CERTIFICATE OF APPROPRIATENESS

Property: 8607 Dover Street, Lot 2, Block 42, Glenbrook Valley Section 7 Subdivision. The property includes a historic 1,330 square foot, one-story wood frame single-family residence and attached garage situated on a 7,150 square foot (65' x 110') interior lot.

Proposal: Alteration – Windows.

NEW WINDOWS INSTALLED WITHOUT PERMIT OR COA

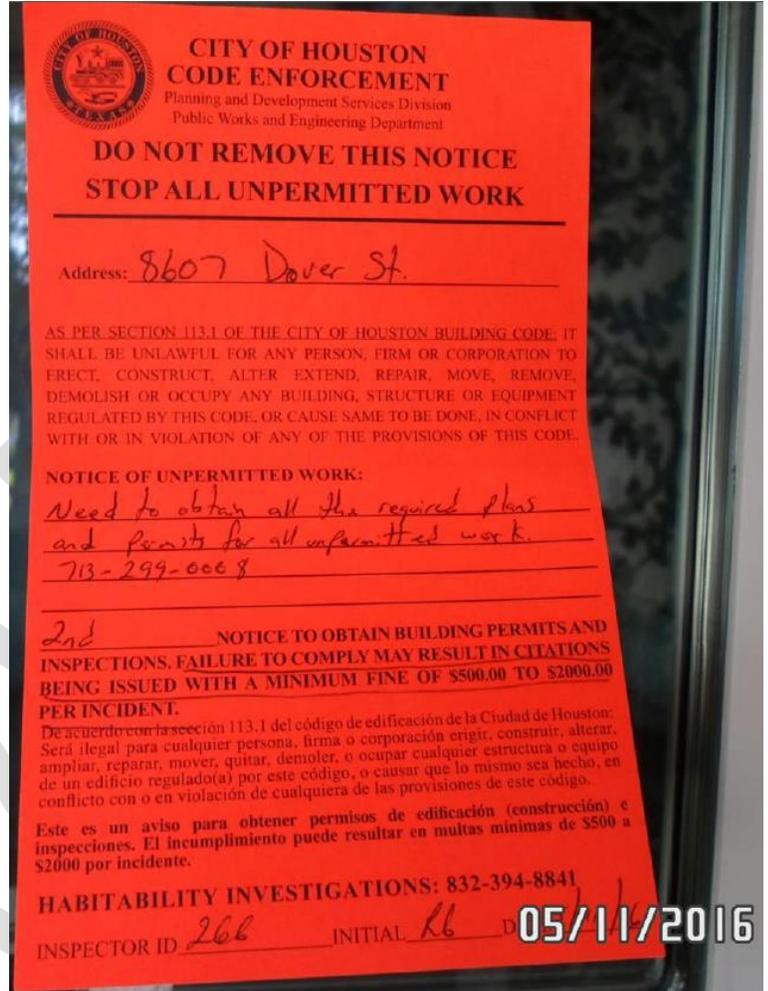
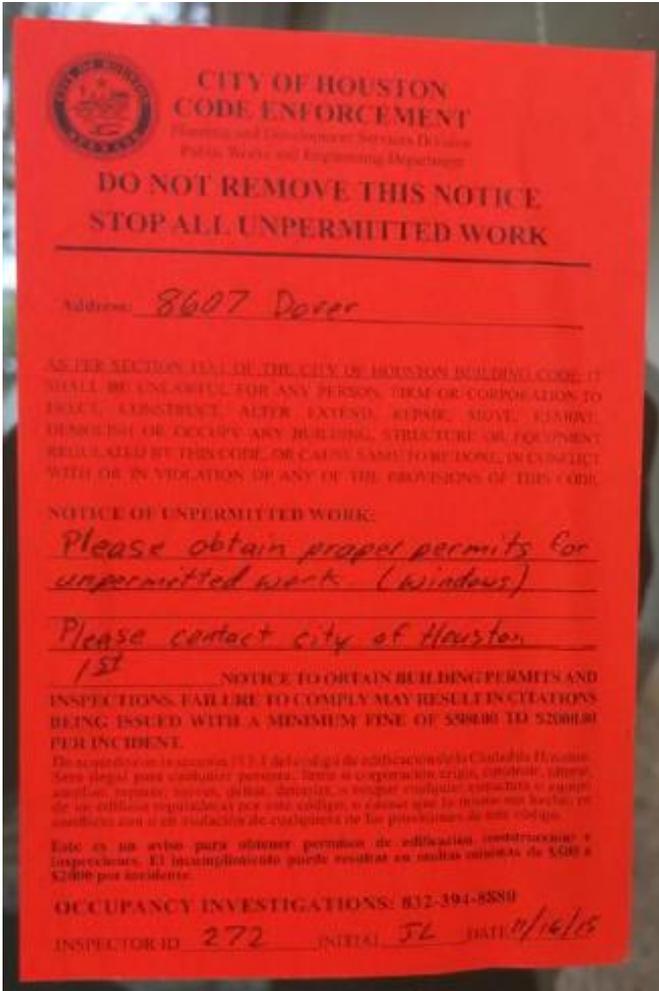
The applicant has removed all 15 aluminum historic 1-over-1 and 2-over-2 windows on the house without a COA or permit and has installed new vinyl 1-over-1 windows. The applicant had previously met with staff to learn about the COA process to replace the windows but never submitted an application.

All windows were destroyed at the time of removal and removed from the site, therefore staff was unable to assess their condition to confirm that they were damaged beyond repair.

<i>Some of the proposed windows seek to create a later appearance by introducing a different lite pattern than the original, 1-over-1 instead of 2-over-2.</i> |

<i>The proposed windows seek to introduce a new 1-over-1 lite pattern instead of the wide, 2-over-2 horizontal panes that are a distinguishing characteristic of the structure.</i> |

<i>The proposed new windows are not visually compatible due to the change in lite pattern.</i> |

In addition to any other remedies that HAHC sees fit to require, staff recommends the applicants find and install windows that mimic the lite patterns of the historic windows.
